Lanpro LVIA – Alternative viewpoints from a neighbour assessment carried out on October 18th

VP 'A'

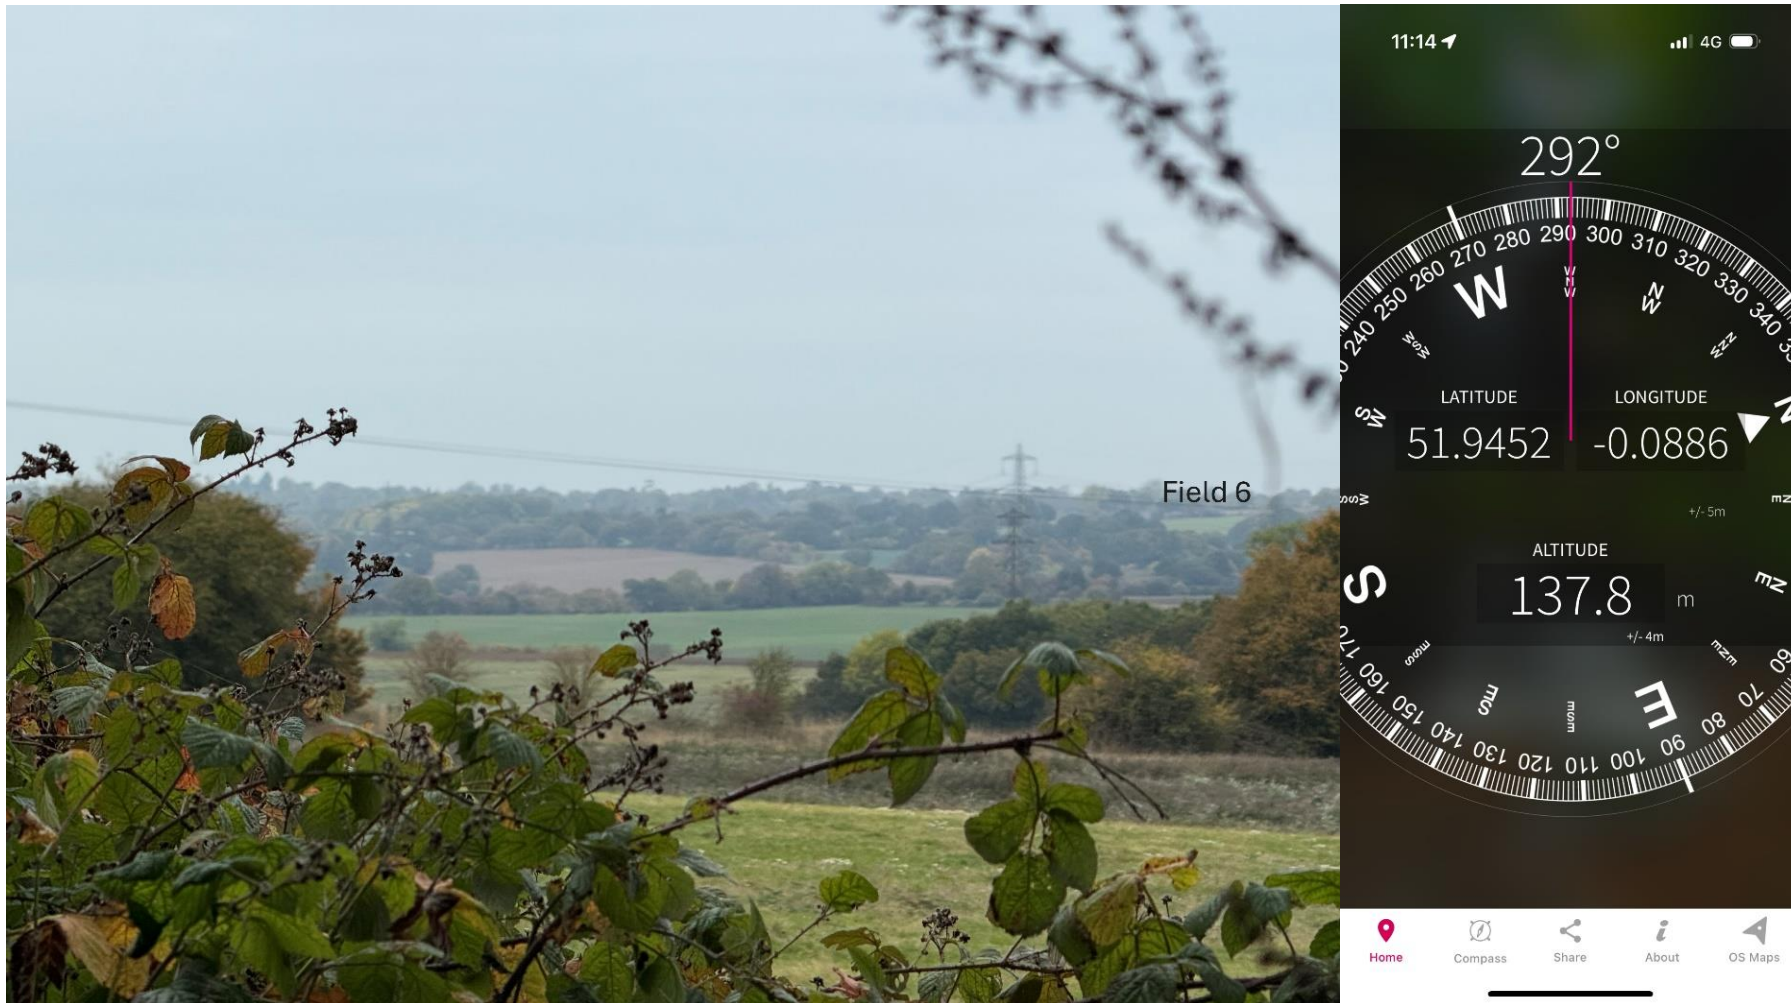
VP 'A' shows the view due west from footpath Cottered 006. Viewpoint VP 'A' sits in between the two viewpoints provided in the Lanpro LVIA (VP13 and VP15) and is at a higher altitude (approximately 10 to 15m higher than those provided by Lanpro and on the same footpath). The BESS and transformer locations are clearly visible along with fields 6 and 10 beyond. Fields 6 and 10 are designated for solar arrays.

VP 'B2'

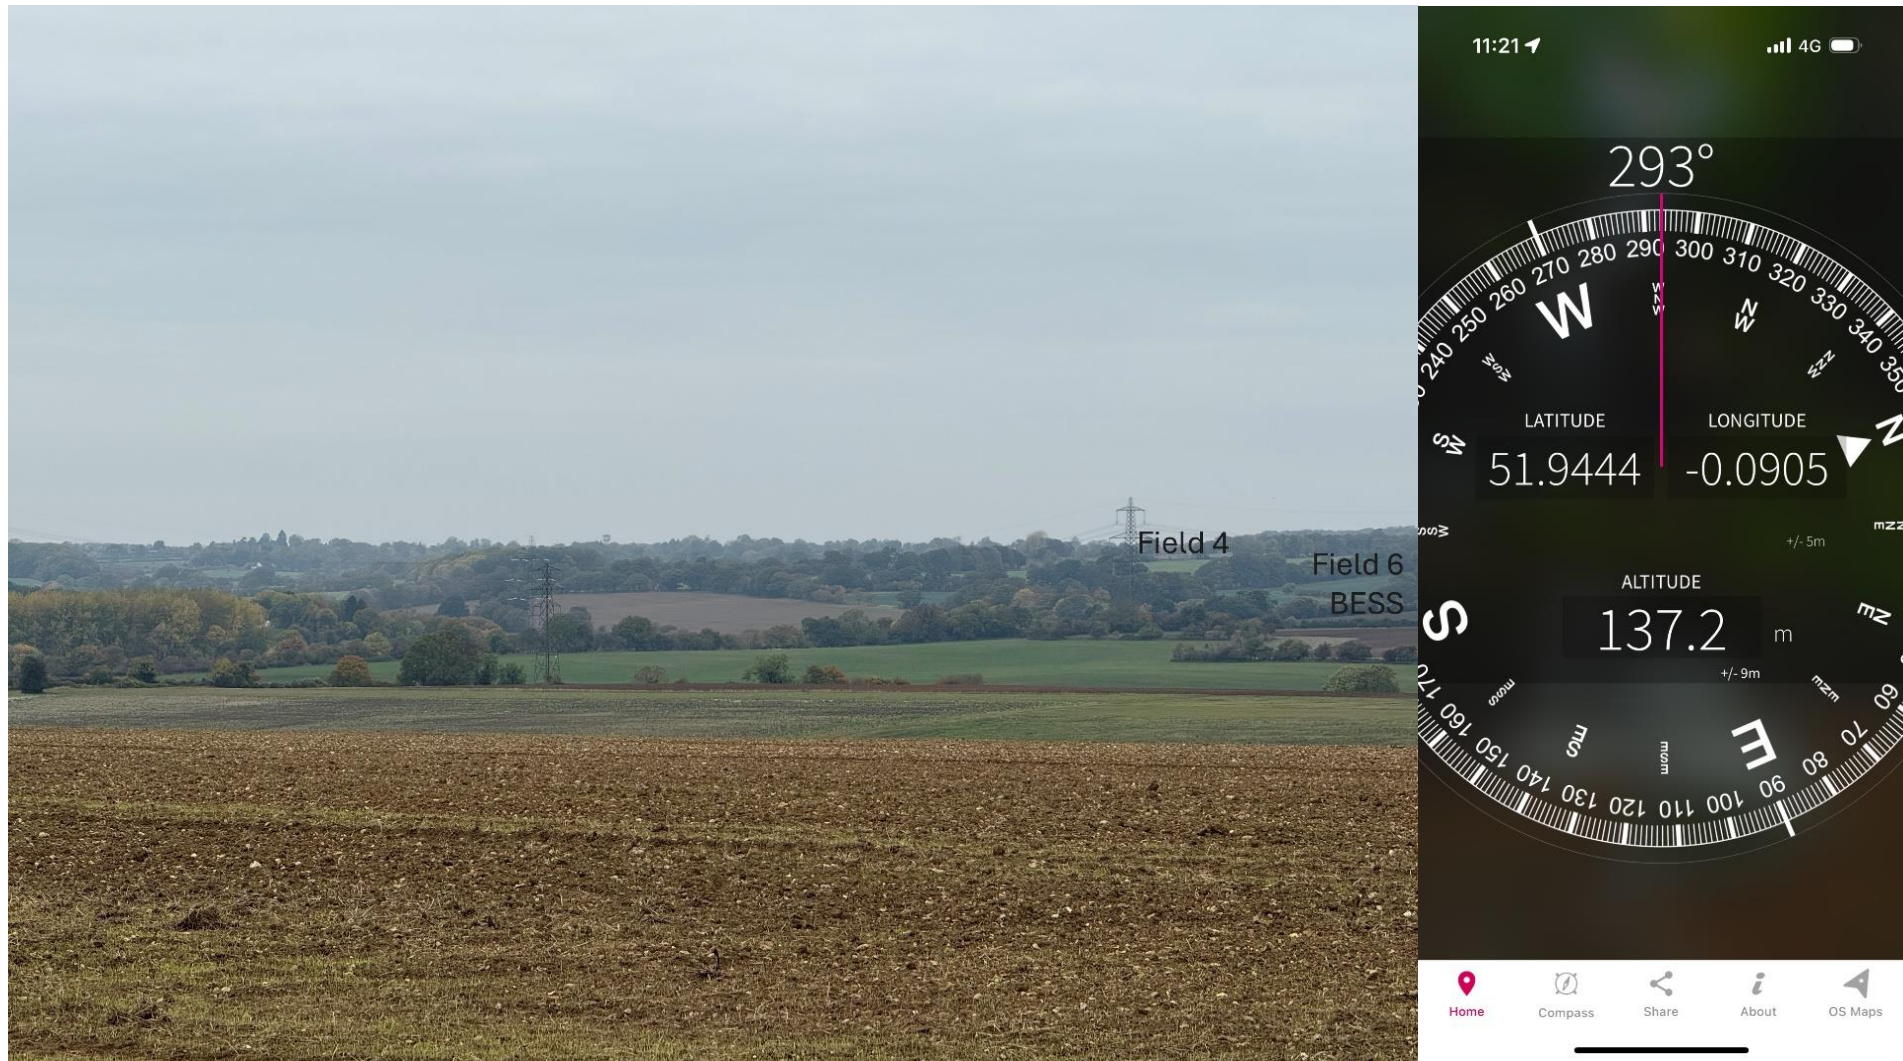
This photograph was added on Wednesday October 22nd and is taken from the bench at the Eastern end of footpath Cottered 026 looking NW. Again, this clearly shows the BESS, transformer and solar panel locations. It is interesting that the East Hertfordshire landscape officer noted this in the report for the Beane Valley Solar application by RES, which they objected to, as it demonstrates that the presence of a community bench to take advantage of the views means that the local community values this landscape.
